From: Edelstein, Gary A - DNR
Sent: Thursday, April 13, 2017 3:21 PM
To: 'Jeff G. Tracy'; Mike Noel
Cc: Joslin, Richard R - DNR; Mary Tierney; Lori Rich
Subject: RE: Ripon Hwy FF/NN Landfill January 2017 Status Report

Wells to be sampled per call with Gary Edelstein

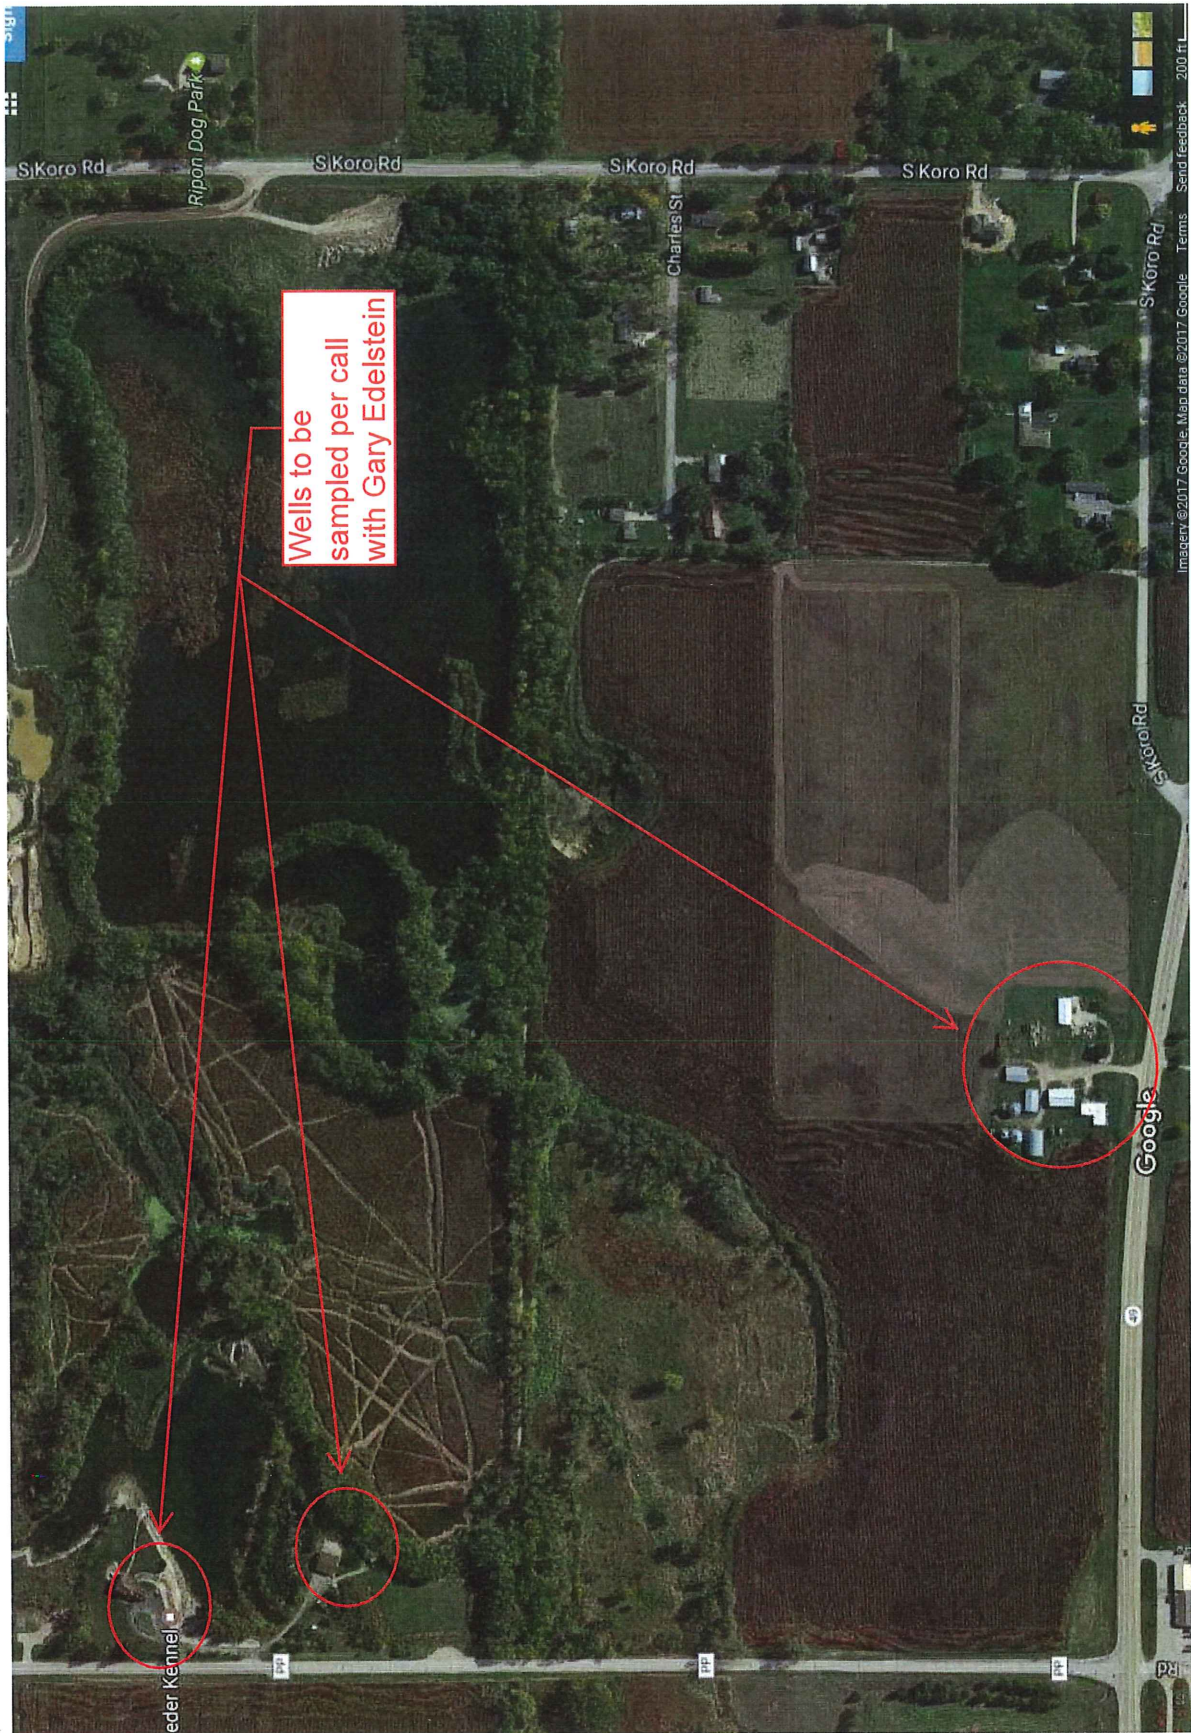
Jeff, this is correct. In addition, I ask that the City confirm there are no new buildings/residences in that area that aren't shown on this photo and to include them if found.

As a result, we would appreciate reaching agreement on sampling certain downgradient private wells immediately. We're looking at the locations to the west and southwest of P-117. Based on aerial photos, there appear to be at least 3 private wells – two along CTH PP to the north of the bike path and one to the southwest of the well to the north of STH 49. Please contact Rick Joslin and I to discuss this as soon as possible.

Gary and I discussed collecting water samples from wells at the properties shown on the attached figure. I told Gary that the City of Ripon would make the initial attempt at gaining access, and that once we have access, we would collect the samples. Gary said that he and Rich Joslin are available to discuss concerns with the property owners, if necessary. I also told Gary that we would provide the laboratory reports, for samples collected from these properties and from samples collected from P-117, after we receive and validate the results.

Gary – let me know if this is not your understanding of our discussion, or if I am not showing the correct properties on the attached.
